Appendix "C2" – Proposed Schedule, Map, and Appendix Amendments – UHOP All Volumes

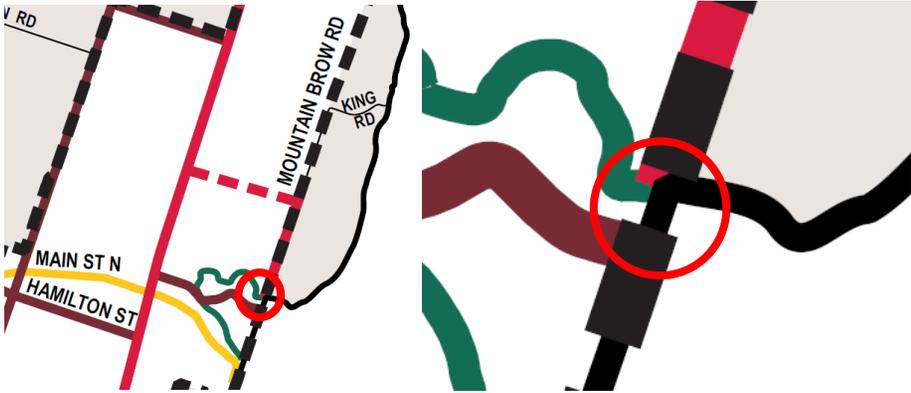
Schedule / Map Number	Proposed Changes	Why Change is Required
<p>Volume 1: Schedule C – Functional Road Classification</p>	<p>Complete the connection of the Major Arterial Road classification for Mountain Brow Road to Mill Street.</p> 	<p>Mapping error.</p>
